The comments in green were made by Kendra Hanagami, and can be contacted at khanagam@auroragov.org

FOUNDRY COMMUNITY CENTER & PARK
SITE PLAN
A PARCEL OF LAND LOCATED IN SECTION 29, TOWNSHIP 4 SOUTH, RANGE 65 WEST OF THE 6TH PRINCIPAL MERIDIAN,
CITY OF AURORA, COUNTY OF ARAPAHOE, STATE OF COLORADO
FOUNDRY SUBDIVISION FILING NO. 1
25950 E. ILLIFF PLACE

SHEET TITLE:
GRADING PLAN

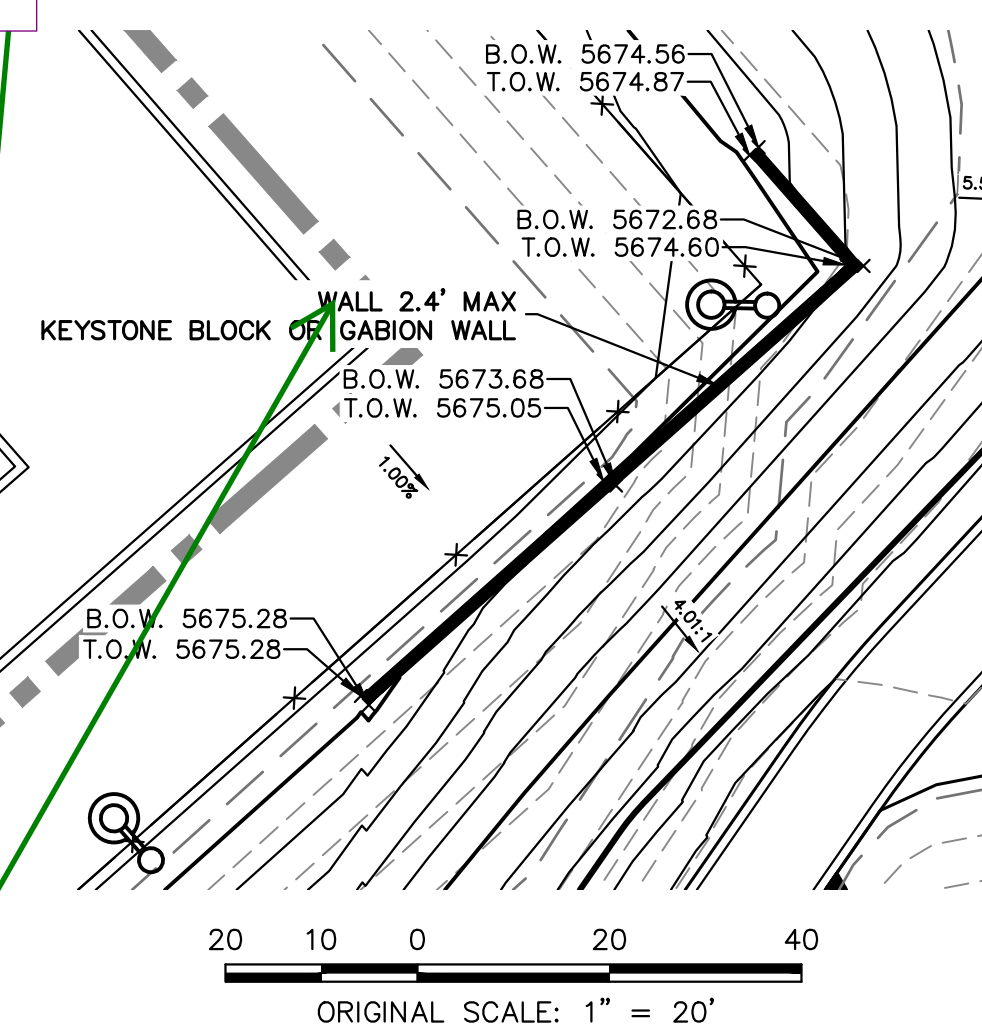
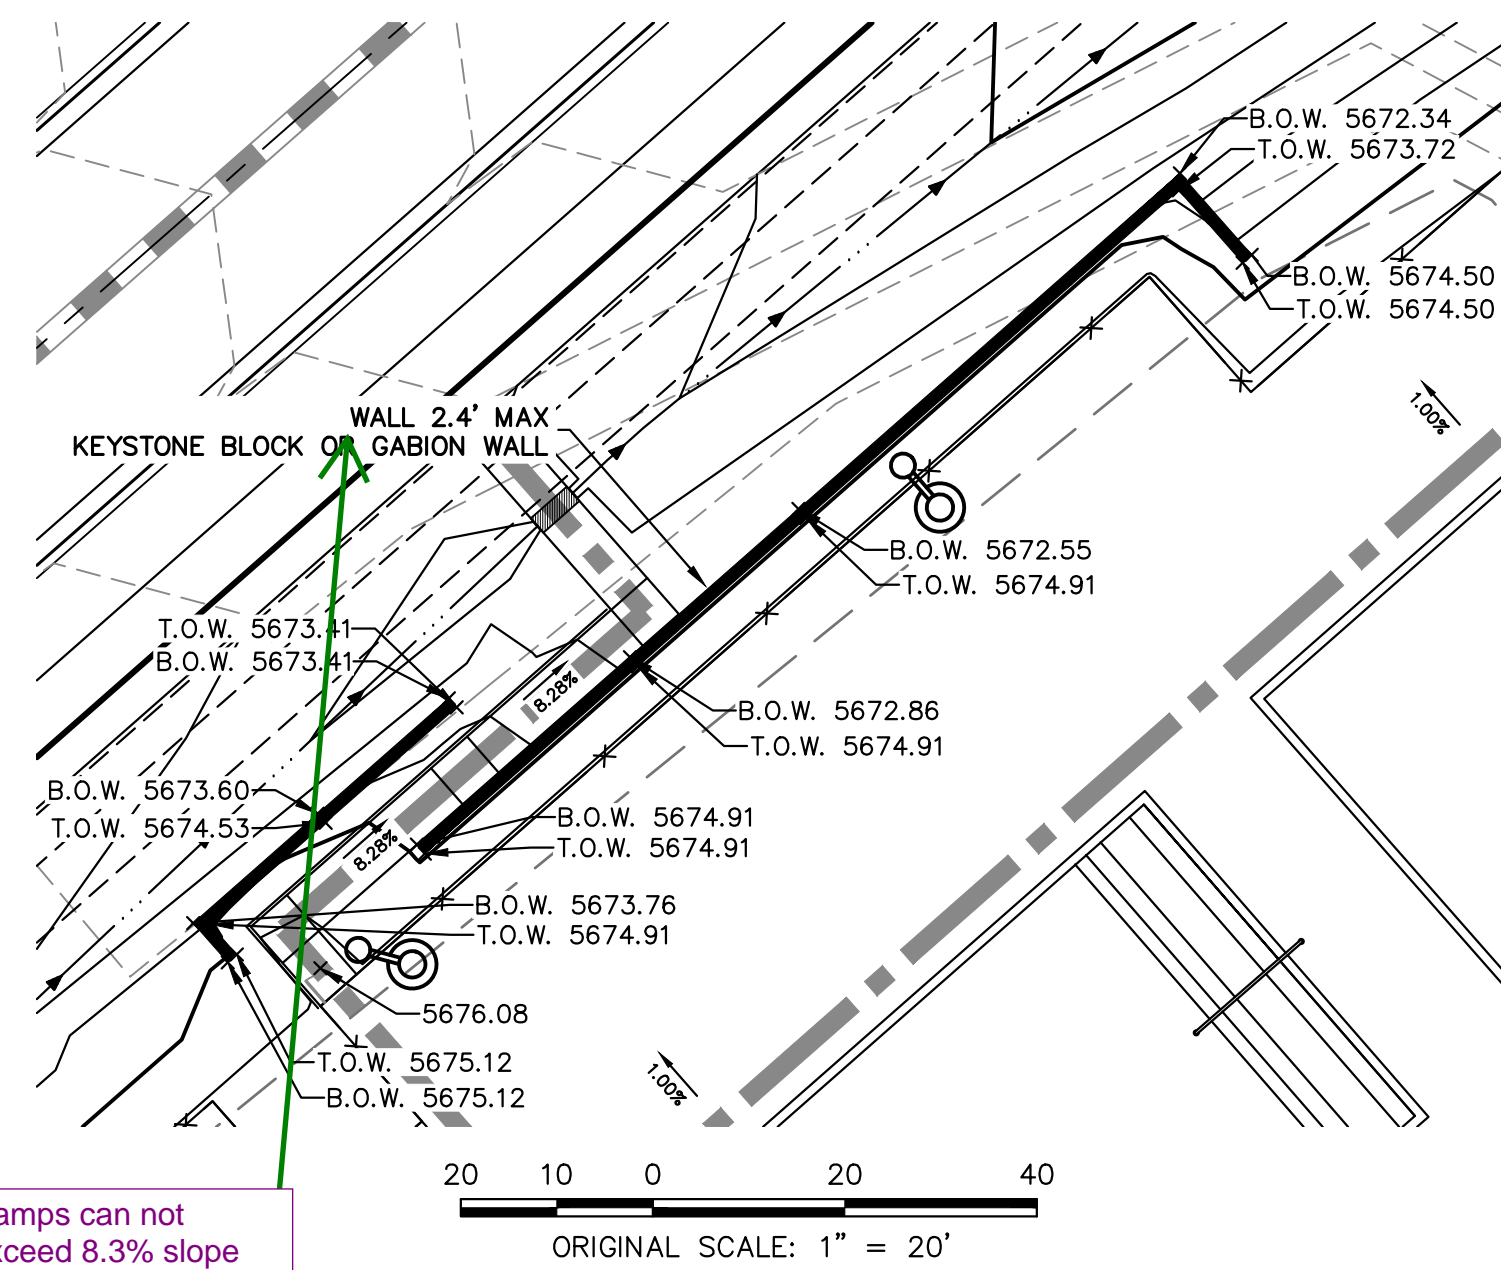
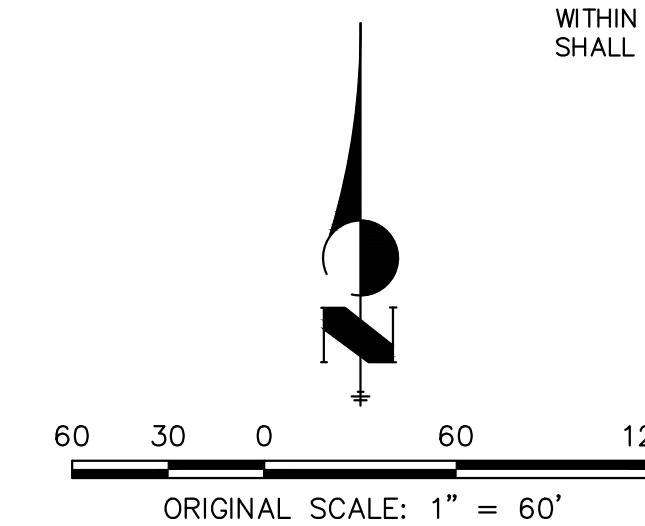
Ramps can not exceed 8.3% slope and must have hand rail

New comment based on new information:

Please add a reference to the retaining wall detail on sheet LP-300

Noted, slope modified since we had room to adjust. For reference this particular location is not intended to be an ADA route but rather a possible maintenance access. This may serve as a possible service route to the pool equipment room if larger repair/ maintenance equipment is ever needed in the future. As such we are considering this to follow maintenance access grades and desired intent to avoid railings. See ada path as identified on legend for reference. All ADA routes comply with these standards.

Addressed,
Text added.

3 POOL ENCLOSURE FENCE

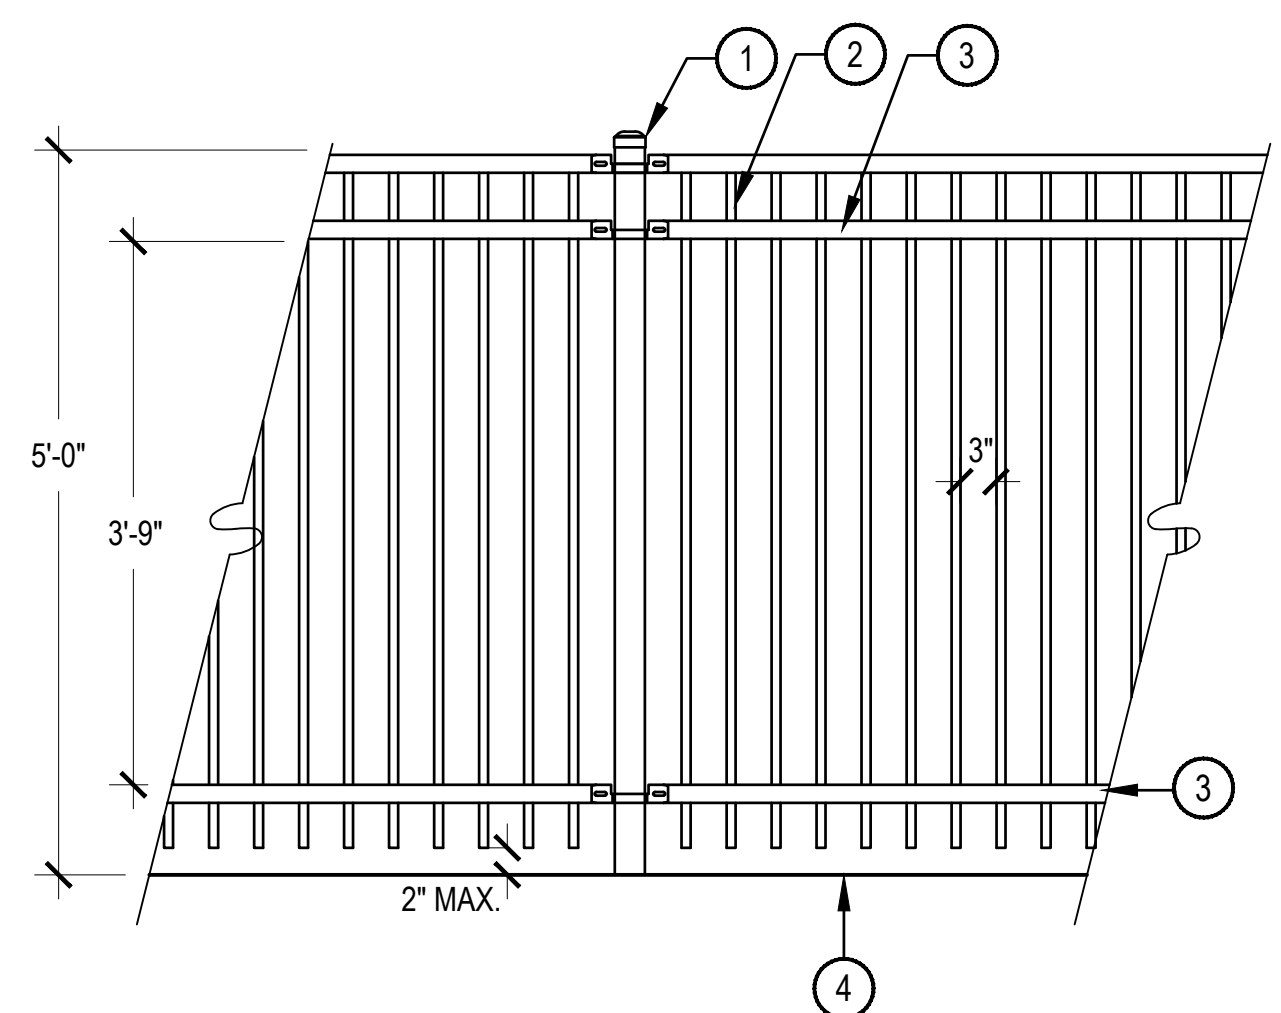
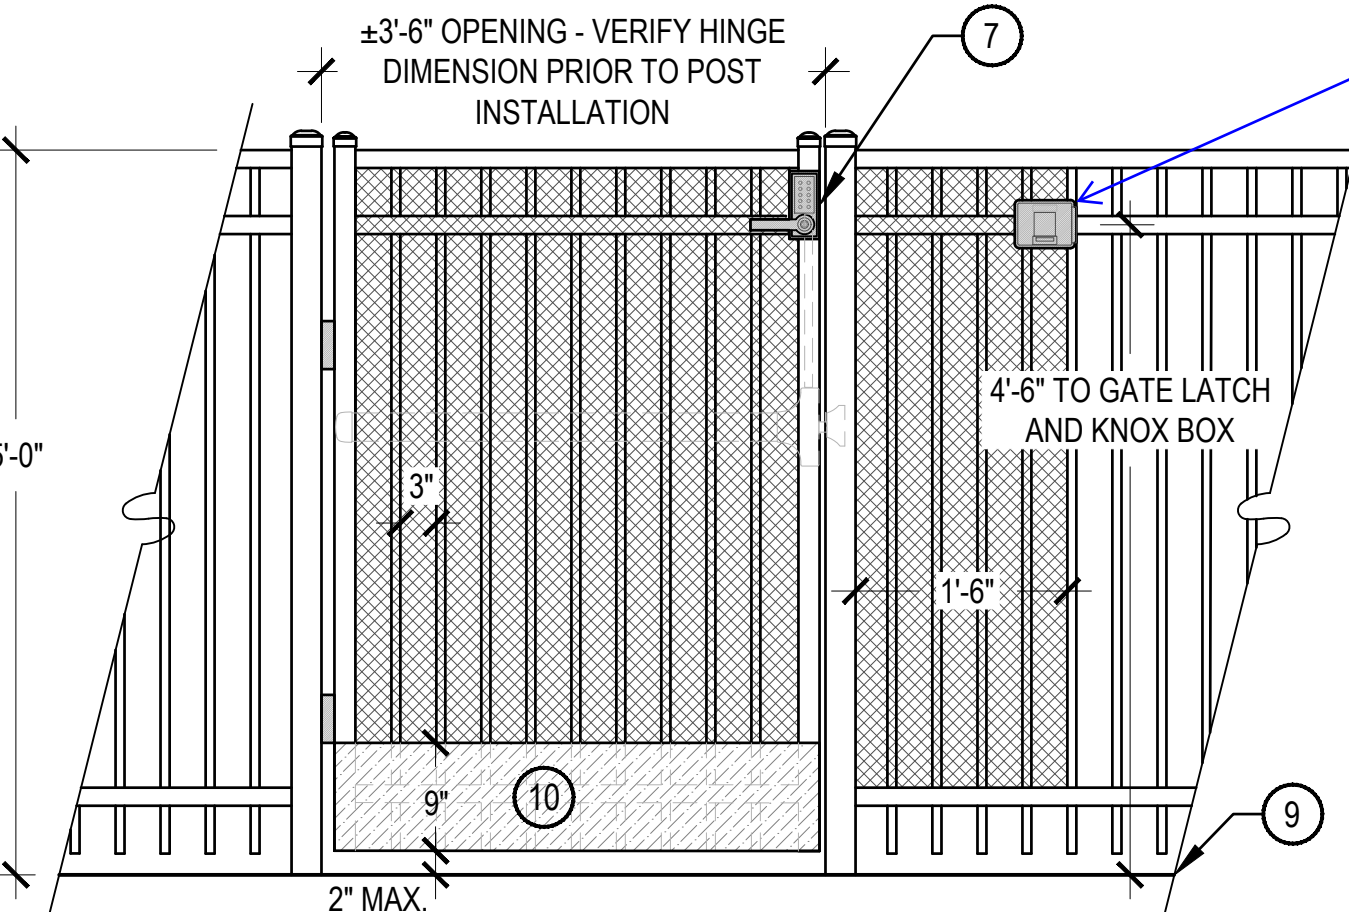
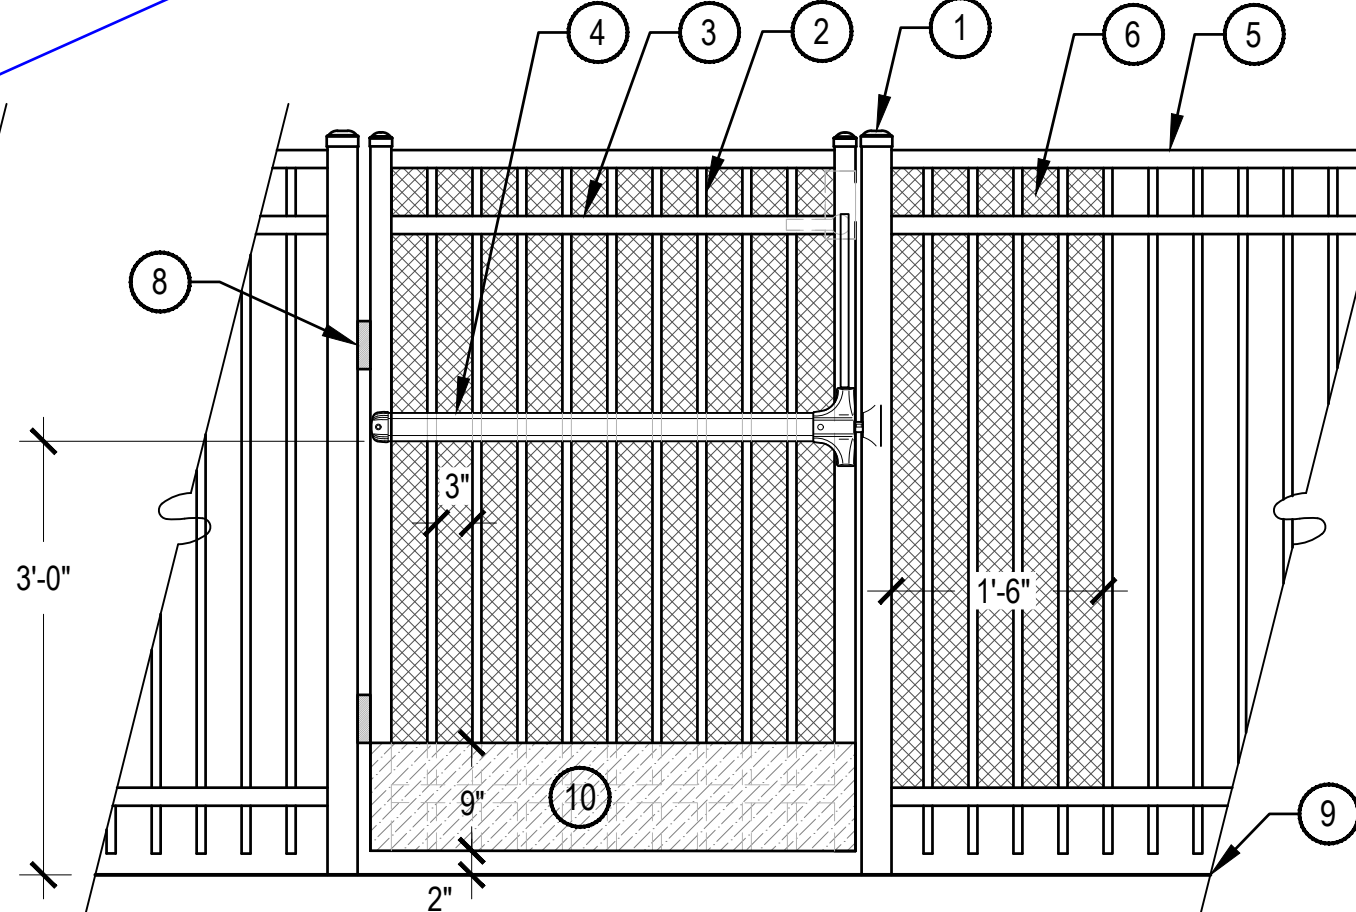
Please use the provided symbol for Knox box. TYP

Response: updated

POOL BUILDING - NORTHWEST ELEVATION

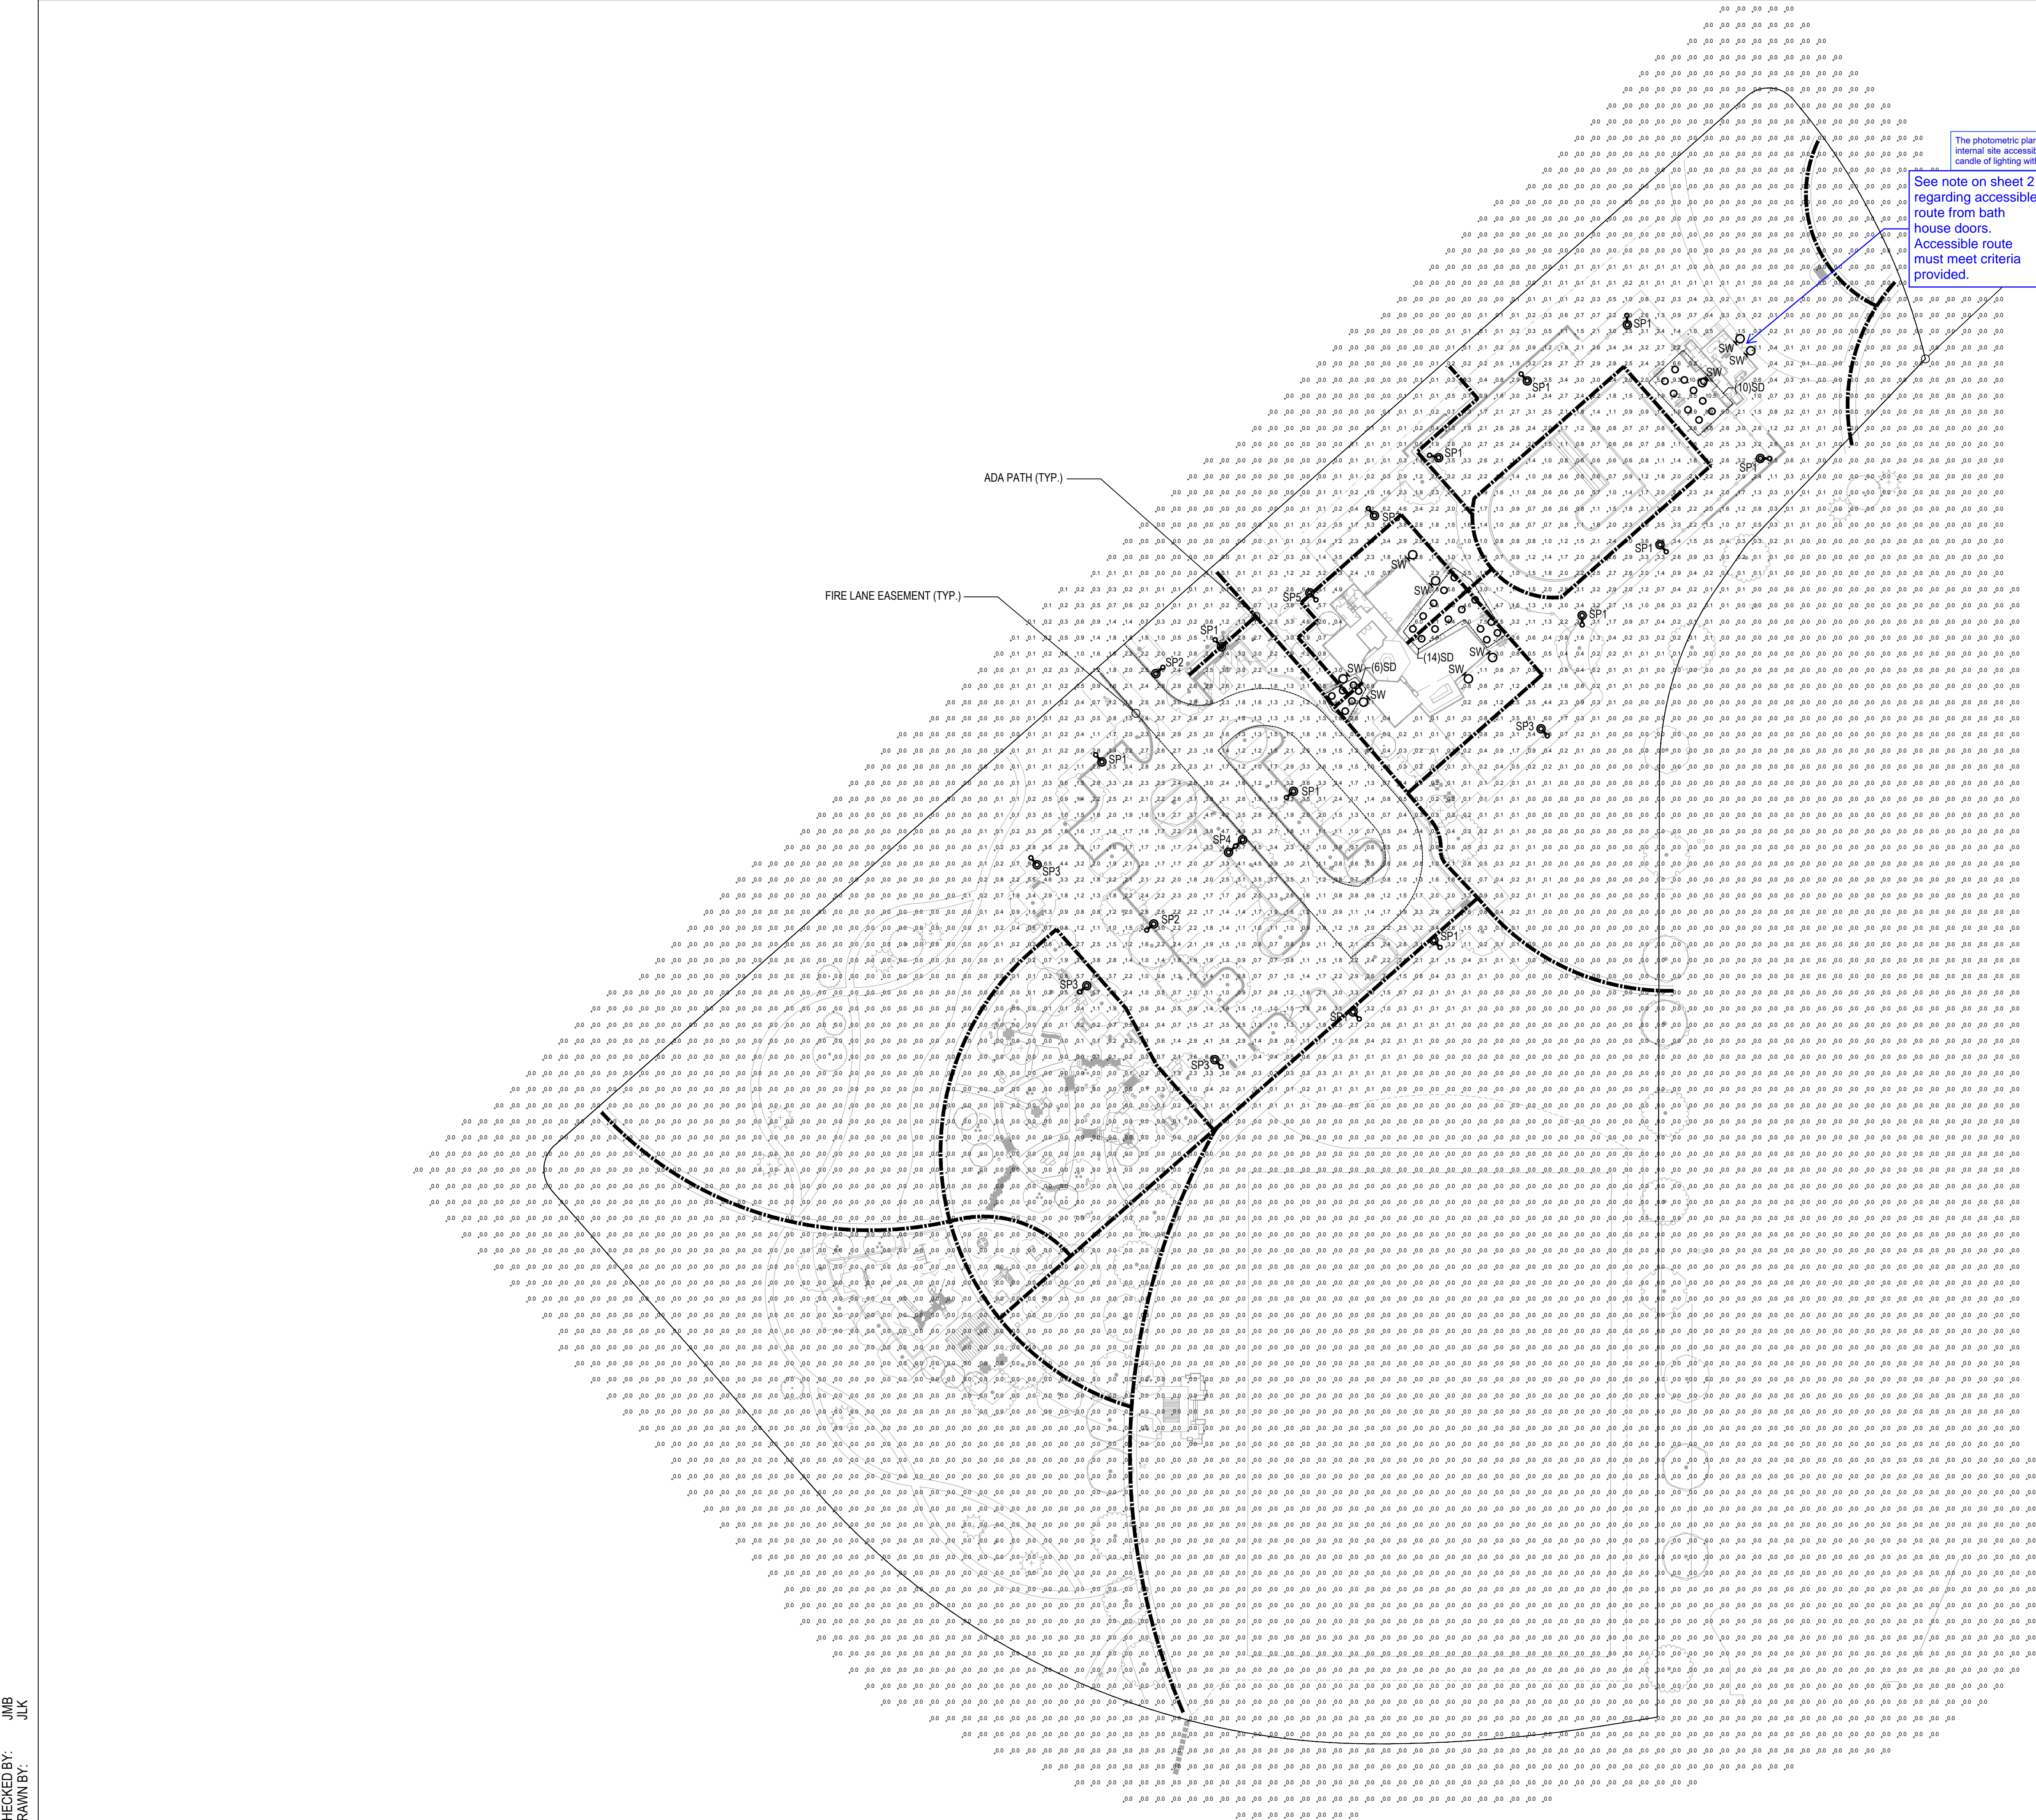
Provide a Knox box at this entrance.

Response: See revised elevation
